COMMENT (1)
PUBLICATION DATE:
12/21/2018
CITATION # 83 FR 65759

Docket: NRC-2018-0155

Instructions for Completing NRC's Uniform Low-Level Radioactive Waste Manifest (NUREG/BR-0204, Rev.3)

Comments for NRC-2018-0155, NUREG/BR-0204 Instructions for Completing the US Nuclear Commission's Uniform Low-Level Radioactive Waste Manifest

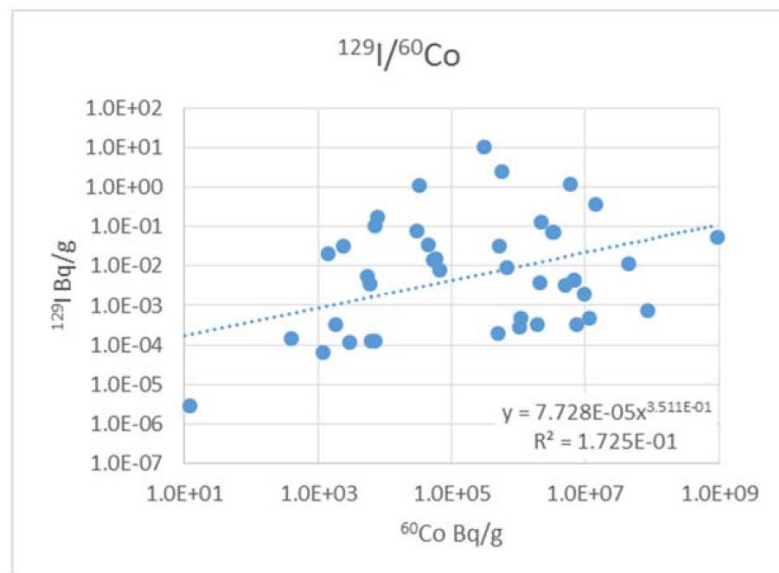
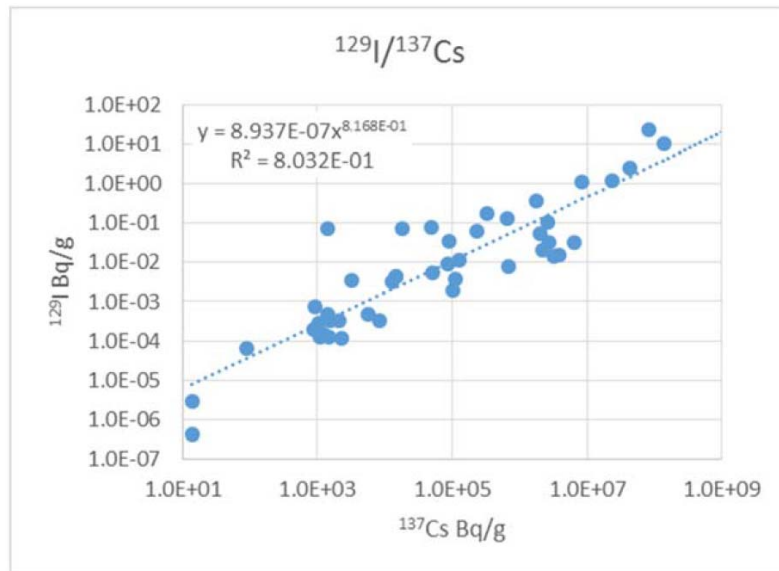
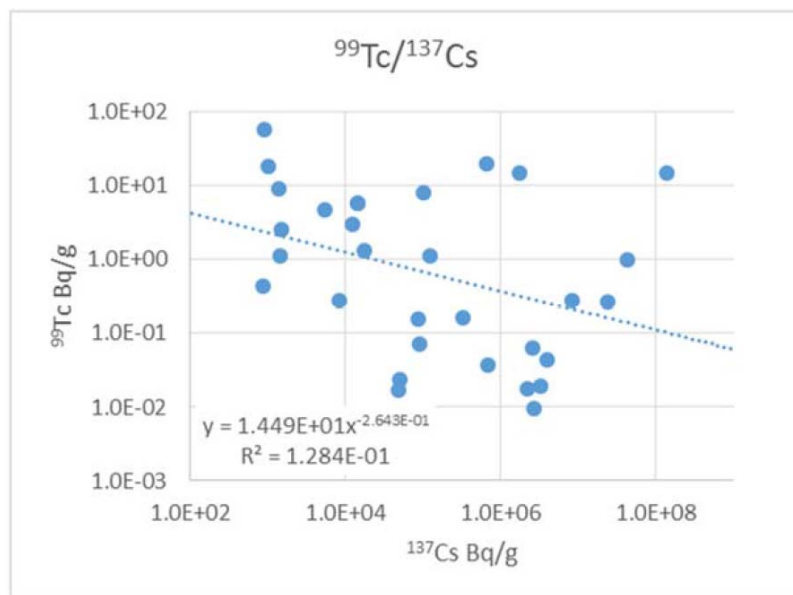
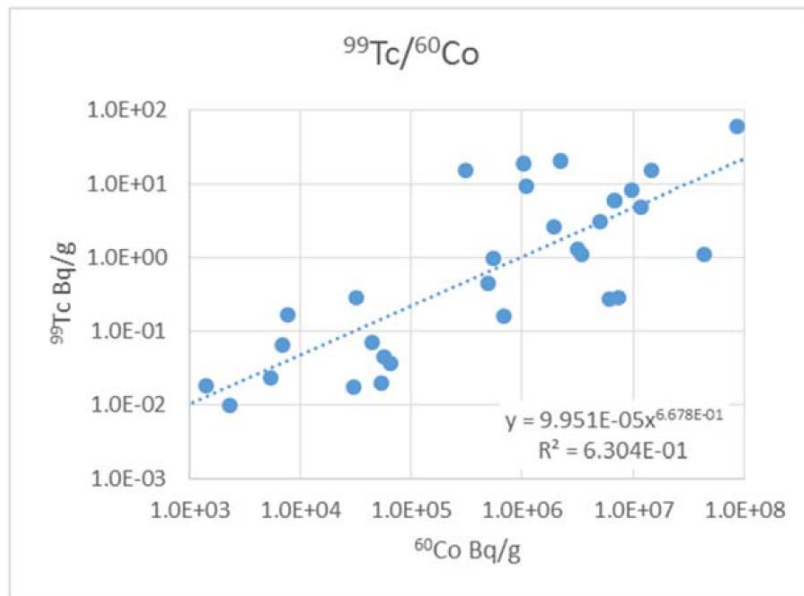
The current NUREG does not try to differentiate between direct measurements and indirectly scaled activity based upon measurements because they are considered to be “determined” or “real” activity values. This once again conflicts with 10CFR61 and NRC Waste Class and Form BTP 1983. Additionally, most of the radionuclides on a shipping paper are determined indirectly from measurements (e.g. H-3, C-14, Fe-55, Ni-59, Ni-63, Sr-89, Sr-90, Nb-94, Am-241, Pu-238, Pu-239, Pu-241, Cm-242, Cm-244). There should be no action to attempt to differentiate values which are already considered to be “determined” values.

The radionuclides of true interest are H-3, C-14, Tc-99, and C-14. Indirect scaling factors to other measurements can easily be determined for H-3 and C-14. The radionuclides Tc-99 and I-129 are always <LLD, so shippers have no mechanism to calculate a scaling factor which would meet the reasonable assurance clause of 10CFR61(a)(8) and supporting regulatory guidance. The LLD value currently becomes scaled to a measurable base radionuclide such as Co-60 or Cs-137 and is reported on the manifest as an LLD value.

It is recommended that no changes be made with the reporting of determined values (e.g. material accountability, direct measurement, inference through direct measurement, or gross radioactivity measurements) and LLD values.

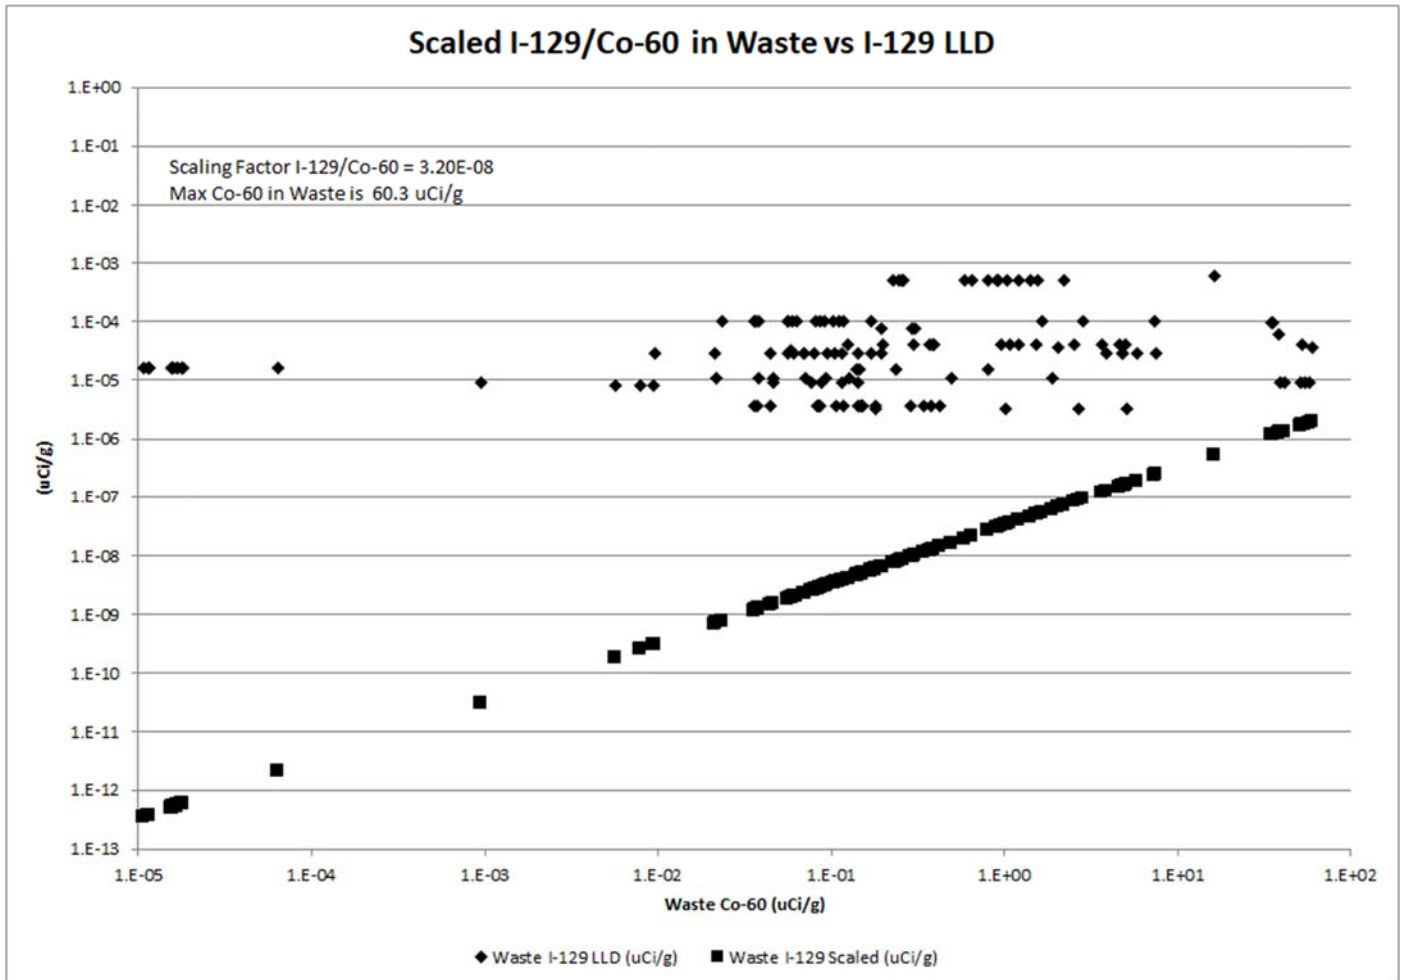
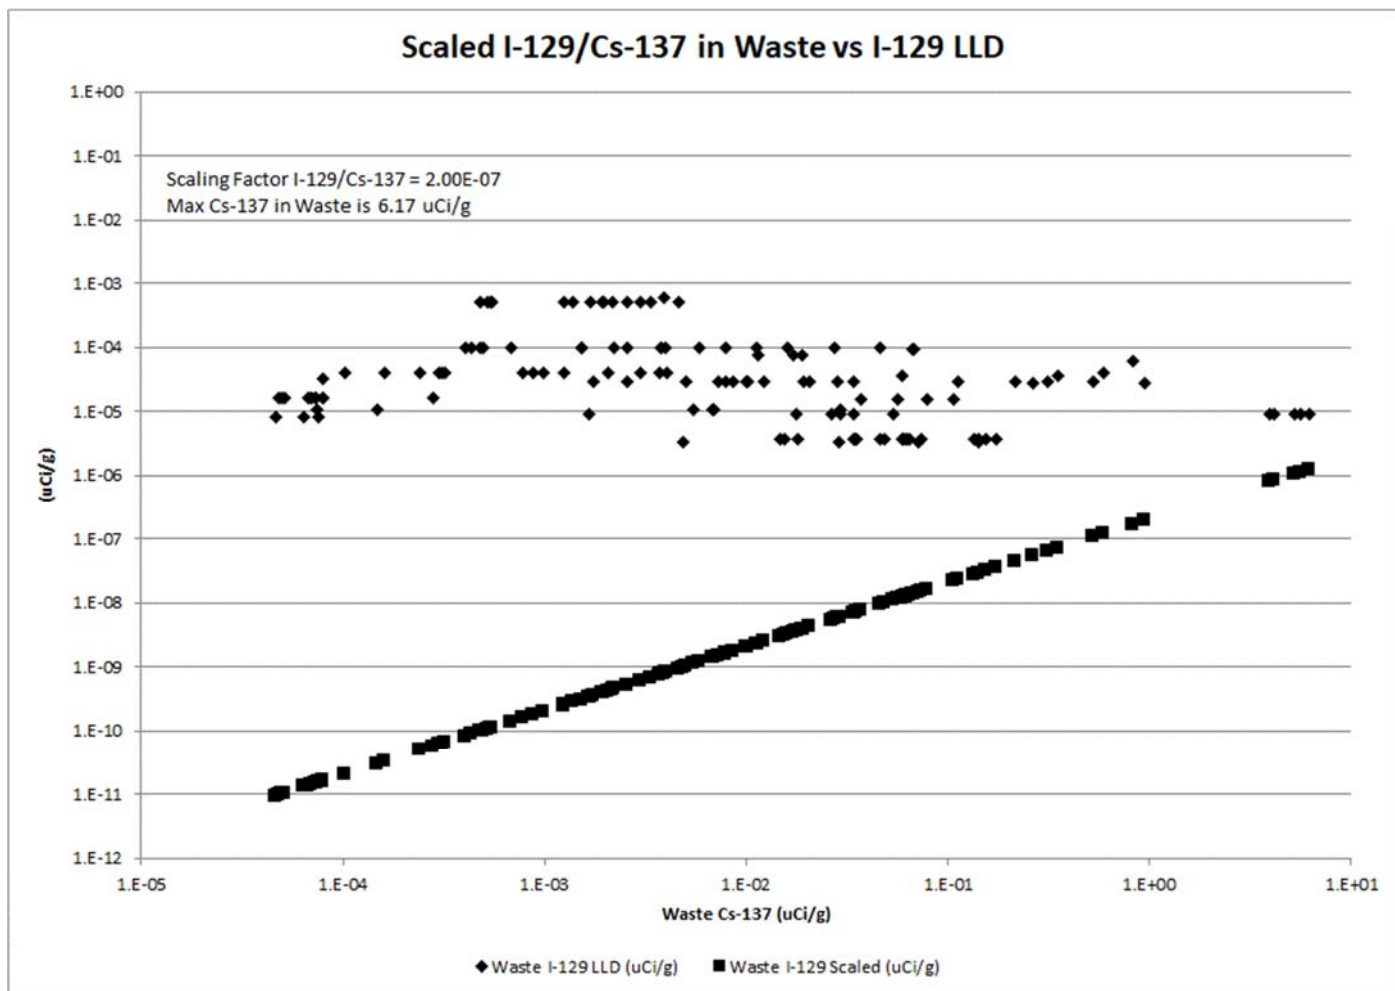
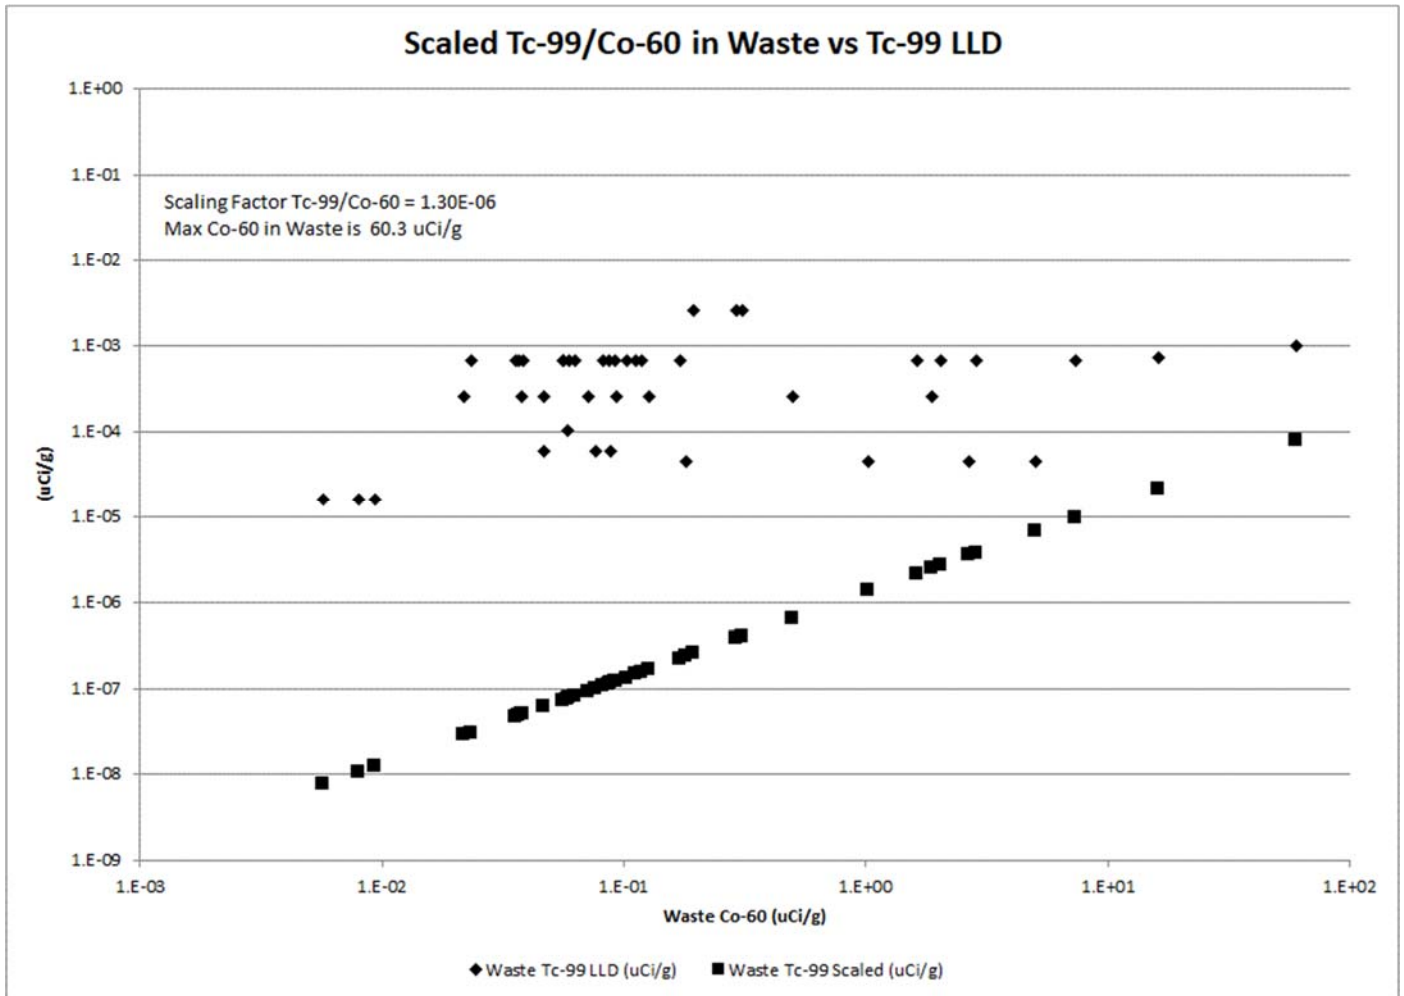
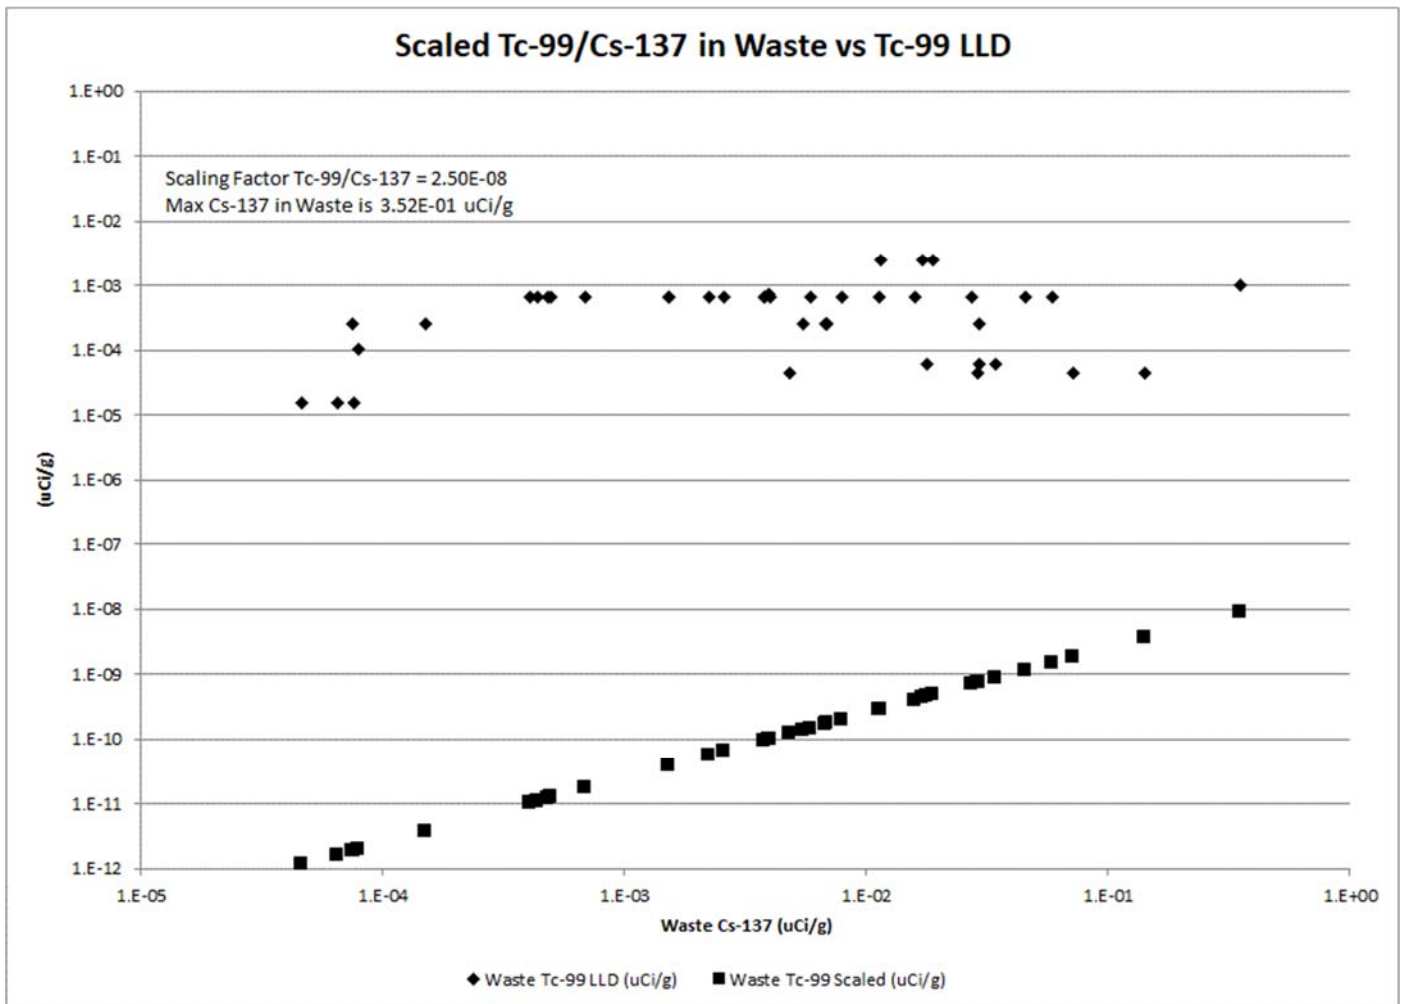
The following figures are from NUREG/CR-6567 and reproduced in the EPRI 2015 work. It is clear there is significant scatter in the data. A factor of 10 is typically applied when comparing an individual data point to the geometric mean of the population when determining if a data point is an outlier and not included in the calculation of a scaling factor. The figures show there are quite a few points that would be outside a factor of 10 of the geometric mean such that there is less certainty of the scaling factor as compared to many other radionuclides with better radiochemical fit.

As previously noted, a shipper would not be able to articulate how their radiochemistry and plant conditions would bound them within this high-scatter data environment within a factor of 10 for a specific waste container. This why the NRC would need to endorse the use of the scaling factors from NUREG/CR-6567 and/or the EPRI 2015 work as best available technology and relieve shippers of the reasonable assurance clause. Otherwise shippers will continue using vendor LLD values.

It is recommended that the NRC endorse the Tc-99 and I-129 scaling factors in NUREG/CR-6567 for use by shippers without further regulatory scrutiny. This would solve everything and there would be no need to alter the current NUREG/BR-0204.
